ADDENDUM #4

North Carolina Aquariums
Jennette's Pier Decking Repair and Replacement
SCO ID# 22-25352-01A

Addendum #04
North Carolina Aquariums
Jennette's Pier
Decking Repair / Replacement
Nags head, North Carolina

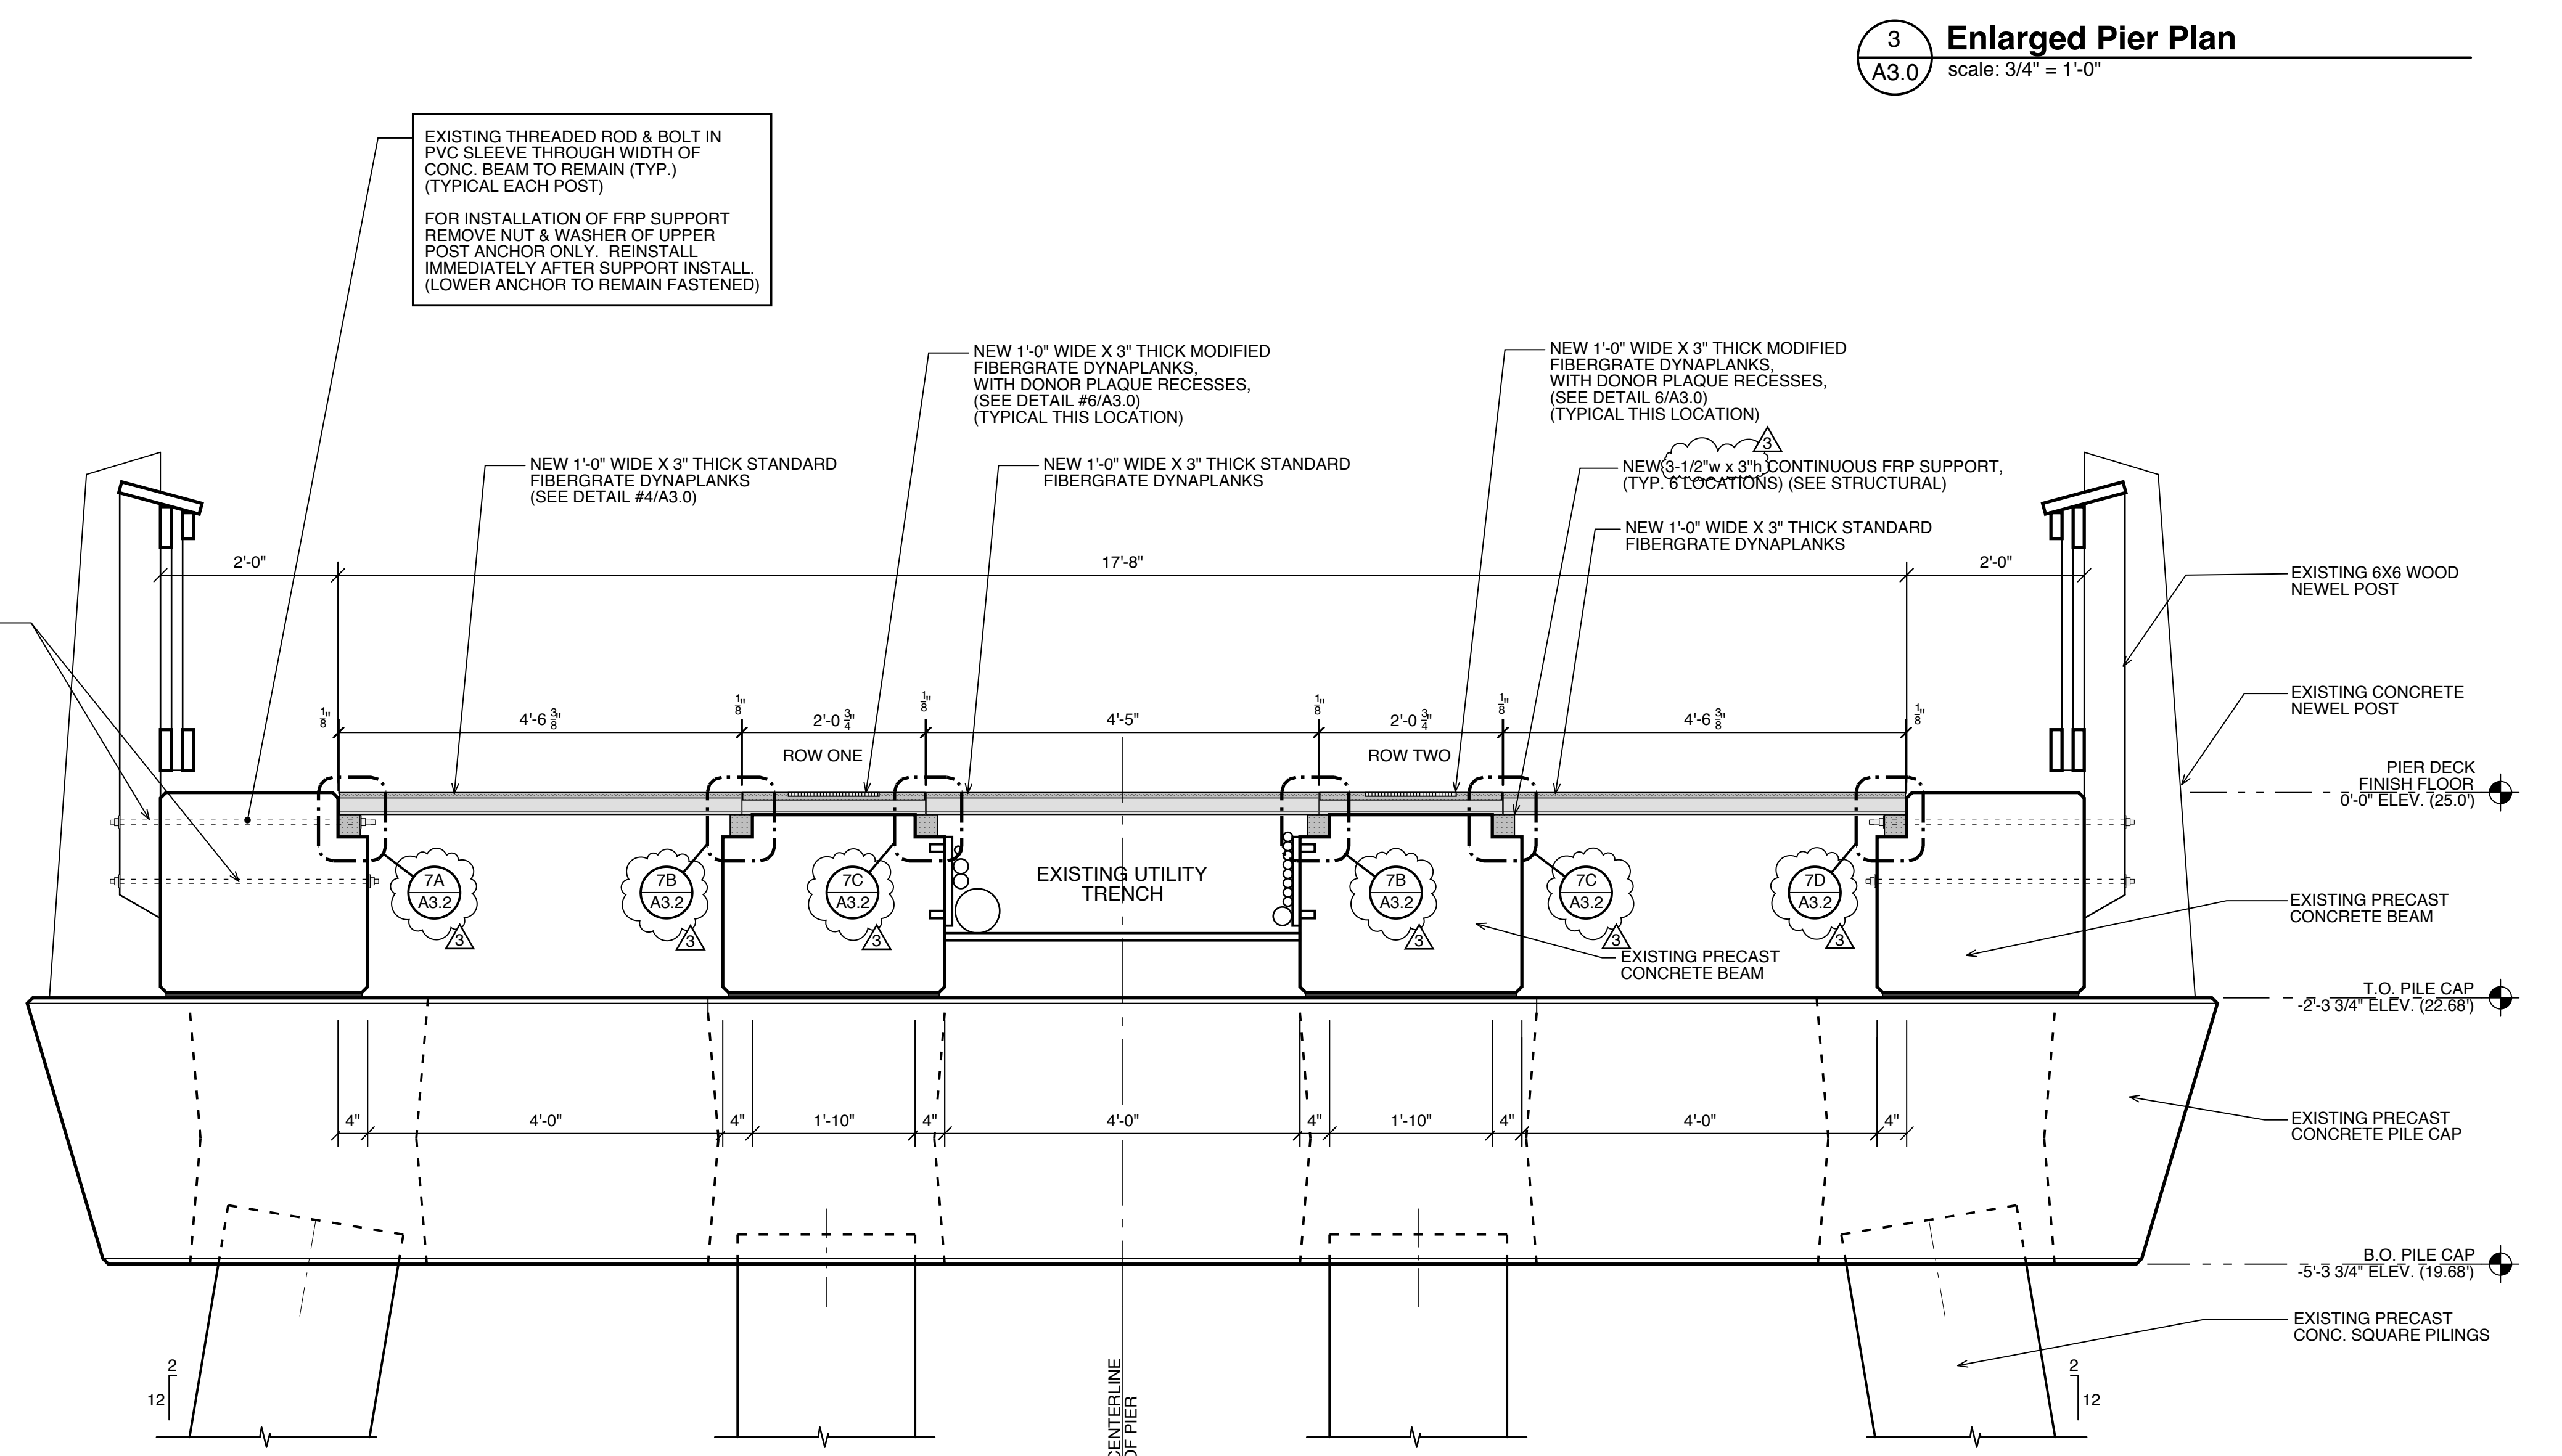
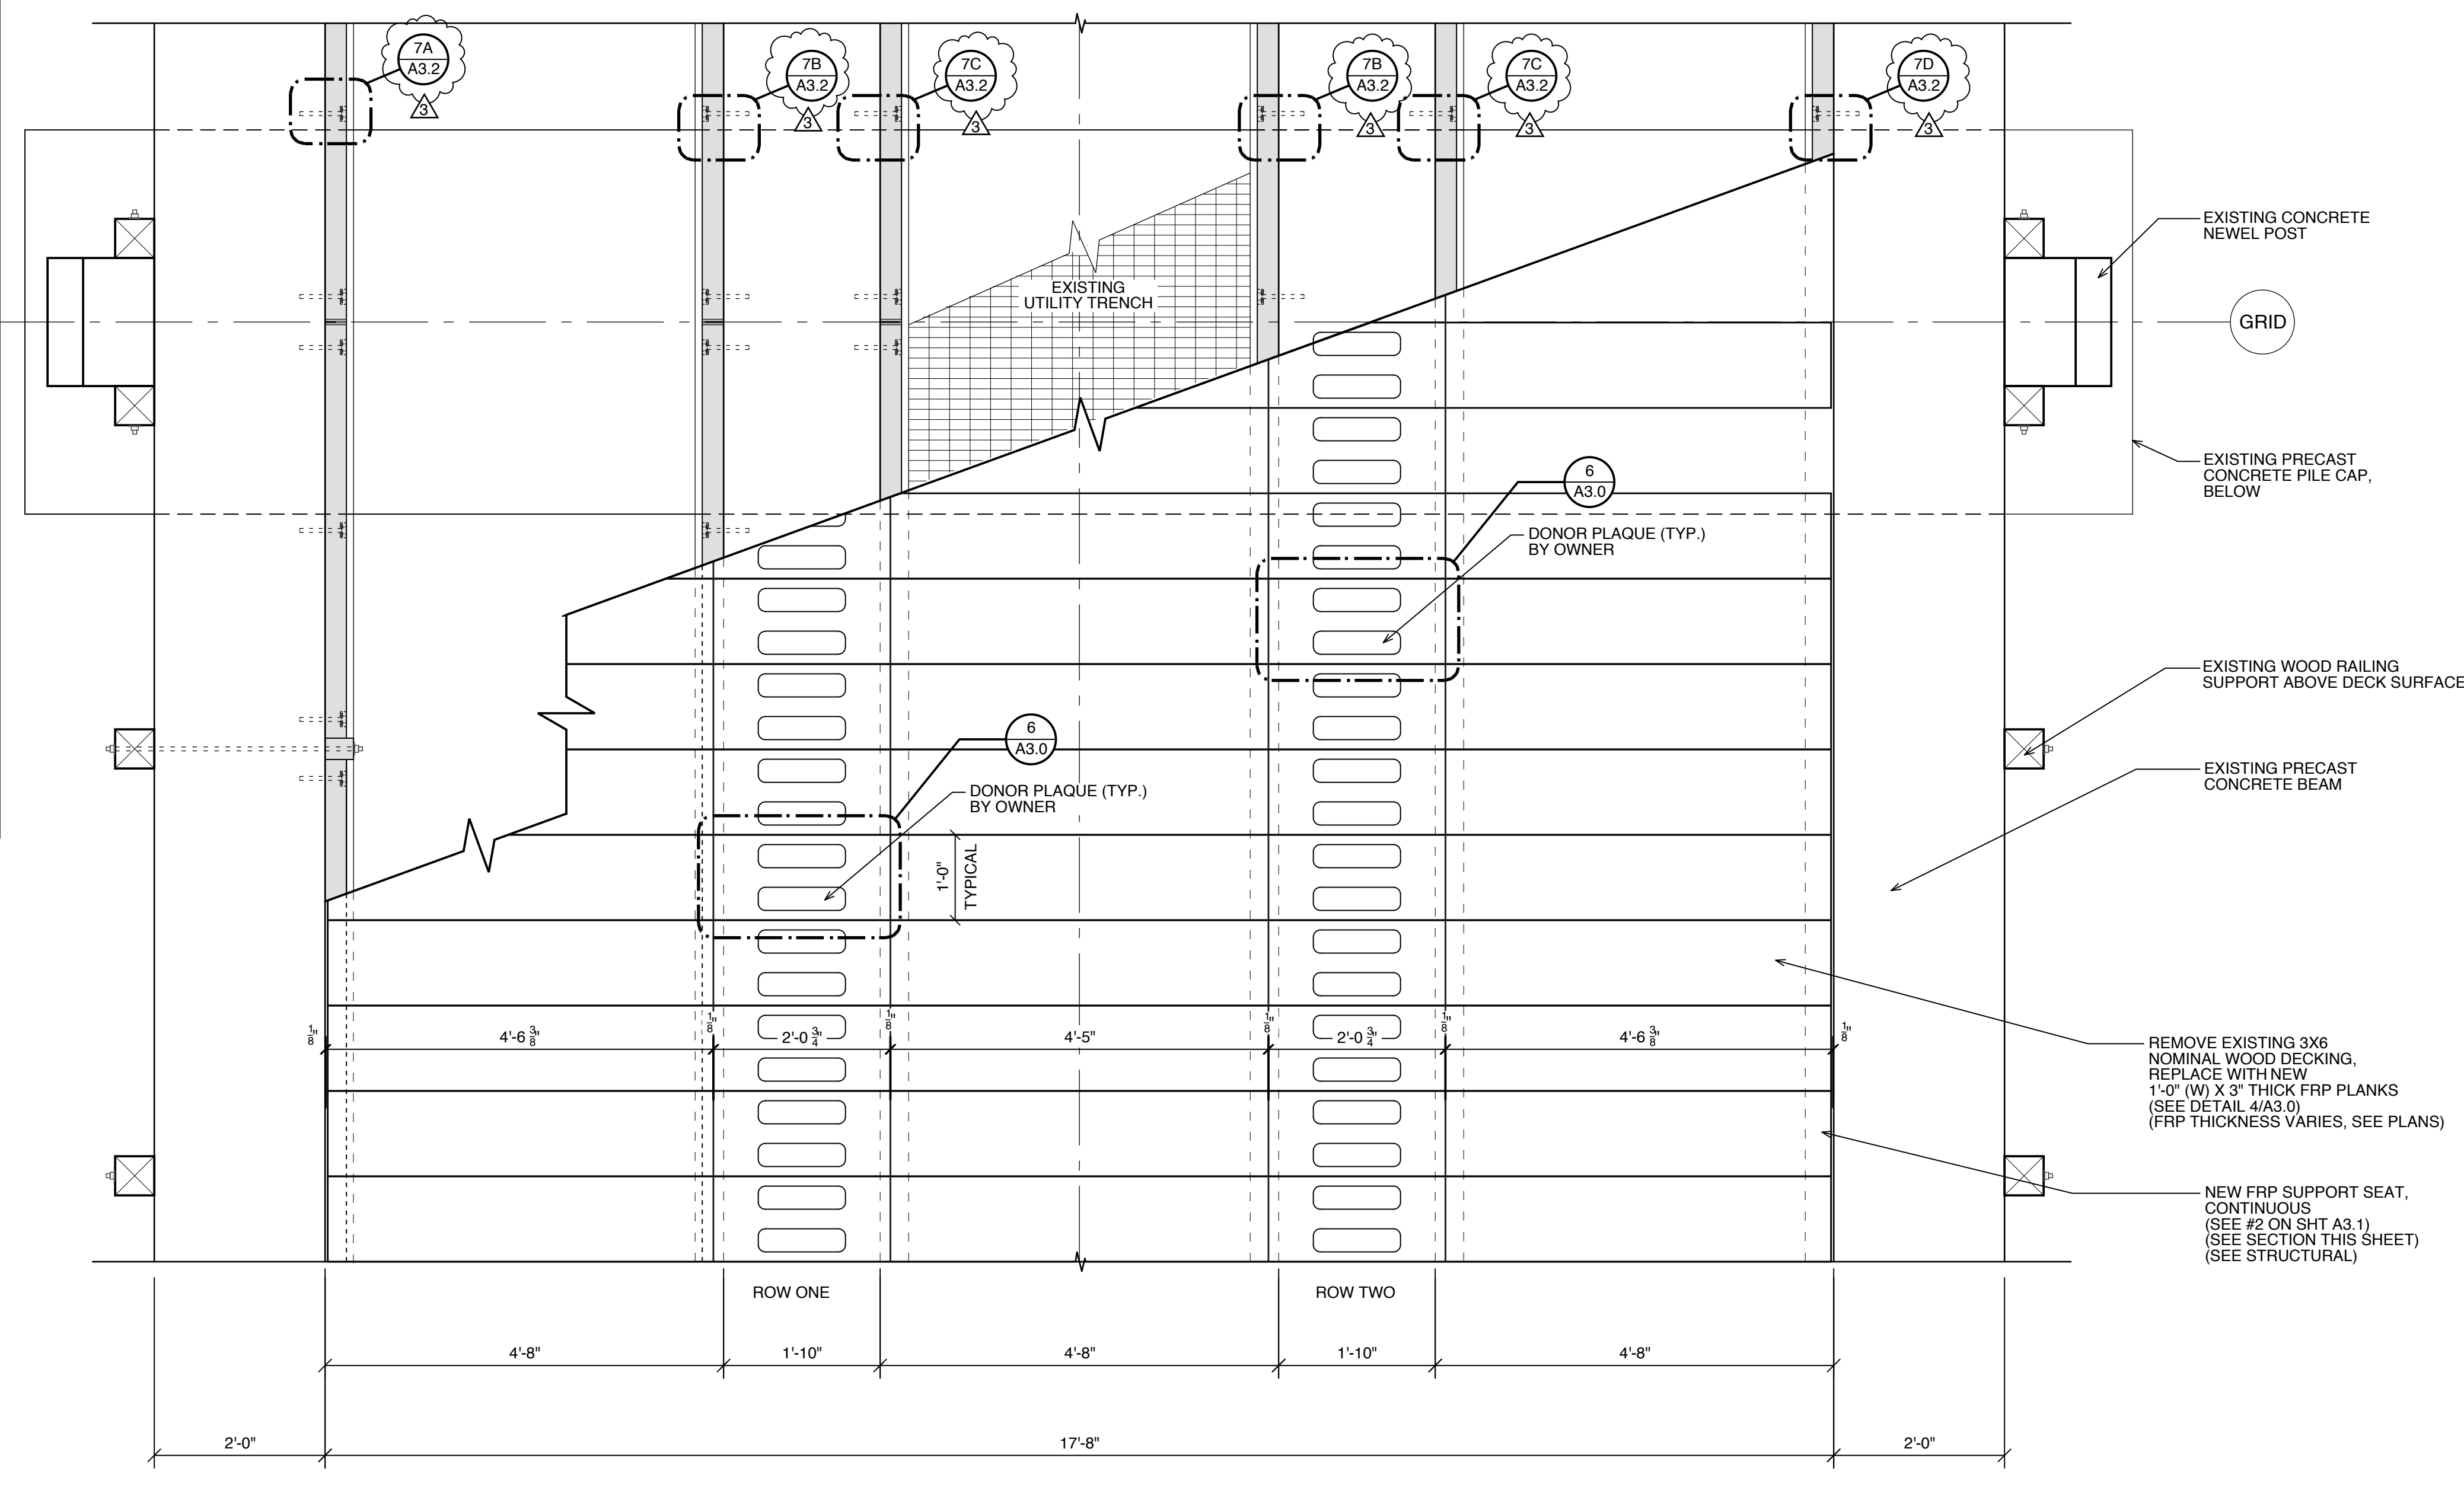
- Item 2** **Drawings – Sheet A2.0** been revised and reissued (see **Attachment #1**).
- a. #1/A2.0 Enlarged Plan now shows 1-1/2" FRP grating at Beach Access stairs #1 & #2. Additional notes have been added at these stairs.

- b. #1/A2.0 Enlarged Plan; notes regarding 2-1/2"x12" FRP planks at start of ramp has been changed to 3"x12" FRP planks.
 - c. #1/A2.0 Enlarged Plan; Location of delineation line between wood framing and concrete has been moved to correct location.

- d. Plan #2/A2.0 Enlarged Bath House Decking; Decking material has changed to 1-1/2" FRP grating. FRP decking shall be used on deck, stairs and ramps. (stairs not hatched for clarity.)

- e. #3/A2.0 Step Detail; Treads and Risers have been changed to 1-1/2" FRP grating. In addition, P.T. wood framing shall be provided on stairs and landing to raise FRP grating to meet top of new FRP decking.

- f. Decking LEGEND has been revised to include the 1-1/2" FRP grating.
- Item 3** **Drawings – Sheet A2.1 and A2.2:** Triangular deck areas supported by wood framing as noted will receive same 3"x12" FRP deck planks as provided in surrounding areas. Disregard notes and legends indicating the use of 2-1/2"x12" FRP planks in these areas. The top of existing wood joists and timber support framing shall be trimmed in place approximately 1/2" to align with top of new FRP ledgers.
